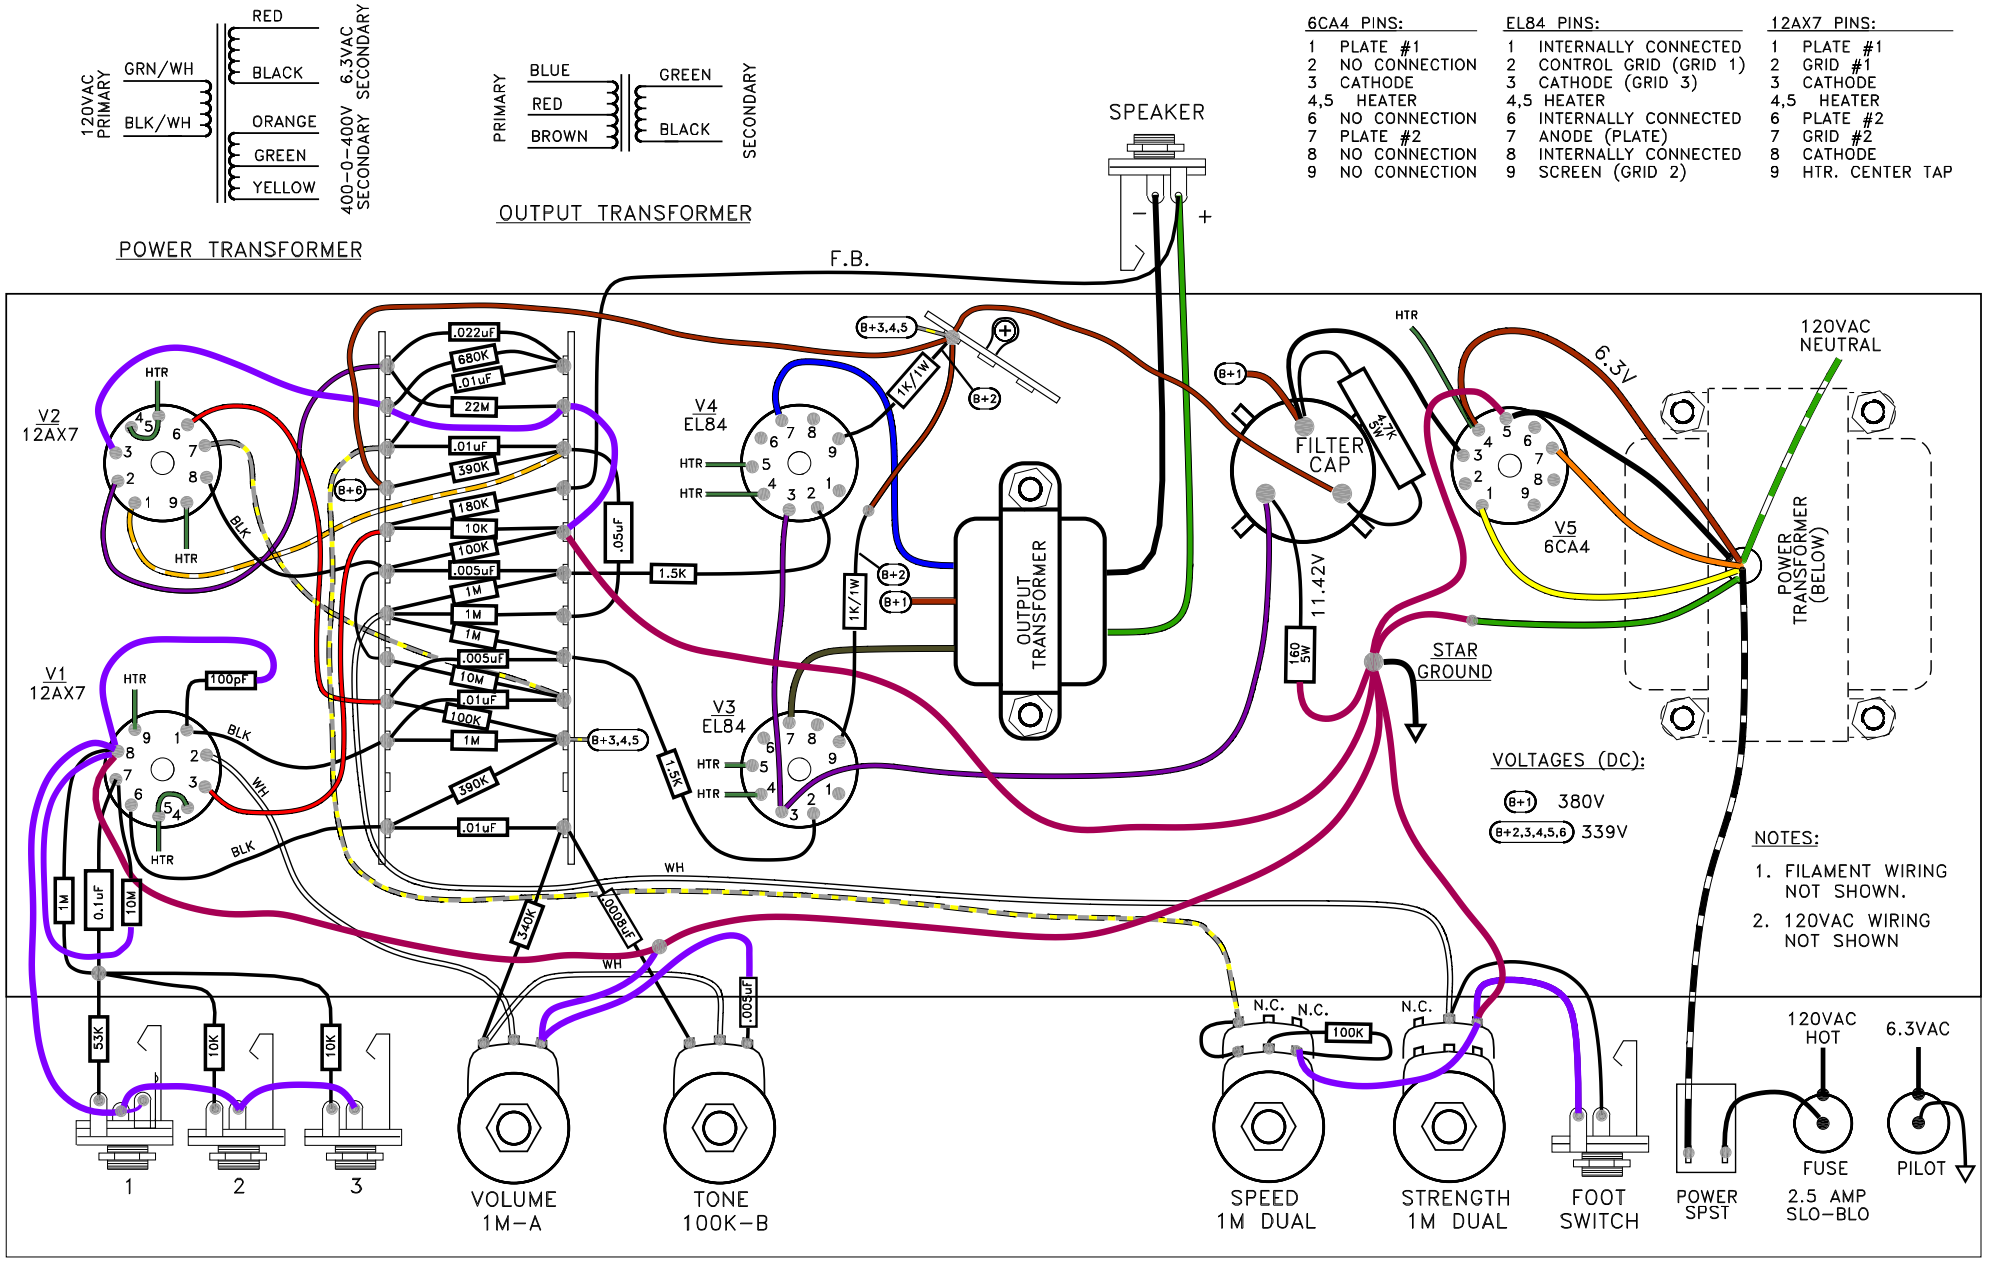
1. 1K SCREEN RESISTORS ADDED AT V3 & V4.
2. VOLTAGES SHOWN HERE DIFFER FROM SCHEMATIC.
